DATE: August 21, 2002
TO: Elaine Stewart
FIRM: METRO
FAX: 503-797-1849
PHONE: 503-797-1515
FROM: Tracy Johnson
PROJECT: Smith Lake Flood Plain Storage
CONTAINS: 2 PAGES INCLUDING THIS COVER SHEET

PROJECT: St. Johns Landfill Slope Restoration / Smith Lake Flood Plain Mitigation Site

Re : Land Use Review for the Smith Lake Project (LU03-100430 EN EF)

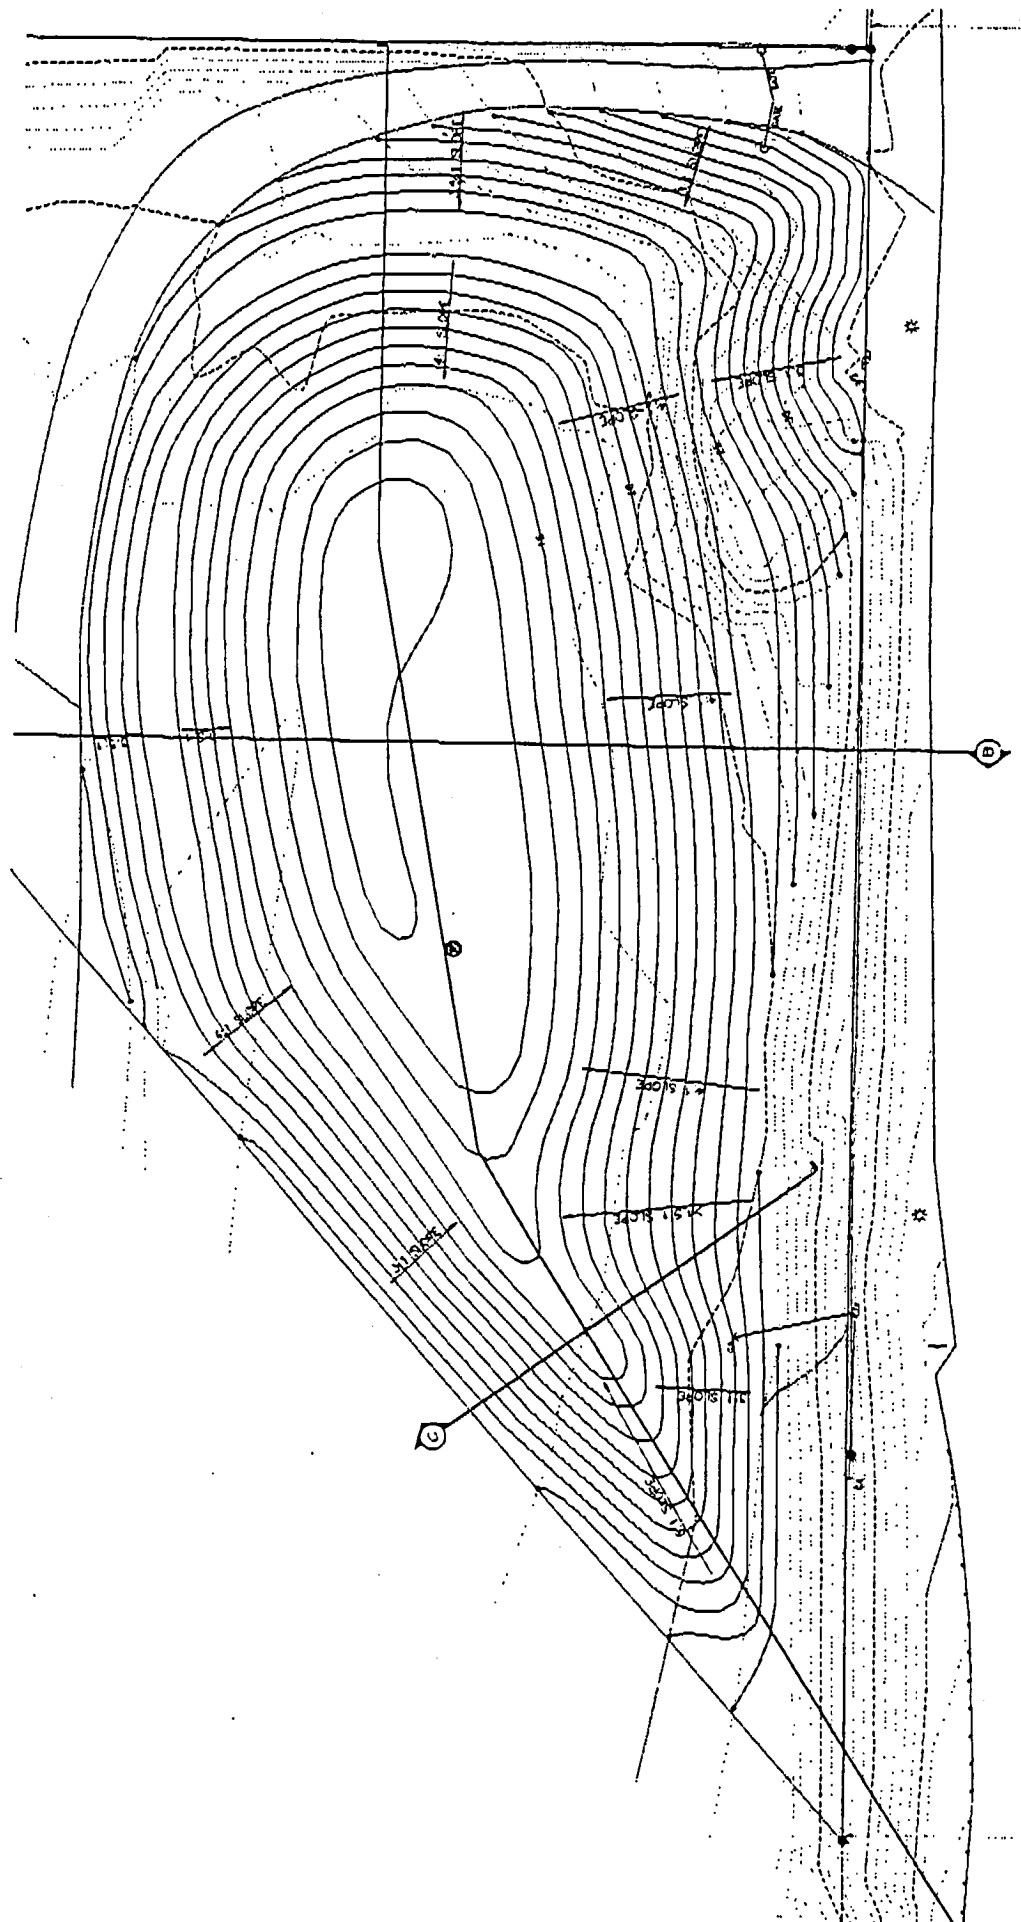
Here is a reduced plan (1" = 40'), which reflects the revisions we discussed over the phone on Tuesday. The removal of the cottonwoods allowed us to ease the slope in that area to over 4.5:1. In the peninsula area, I was able to adjust the 2.5:1 area to 3:1. I also reviewed the possibility of easing the slope in this area further, but found that the only option would be to change the entire section (contours 15 through 35) to 3.5:1 and with that we would lose almost 100 c.y. of cut volume. We felt that a variety of slopes might be more appropriate than a uniform slope in this area, but if you would prefer the other alternative please let us know. If you approve of this grading plan we will release an AutoCAD file to Jon van Staveren for his use, and proceed toward Construction Documents. Please review the attached plan and let us know if you would like any further adjustments.

Tracy -
This looks OK.
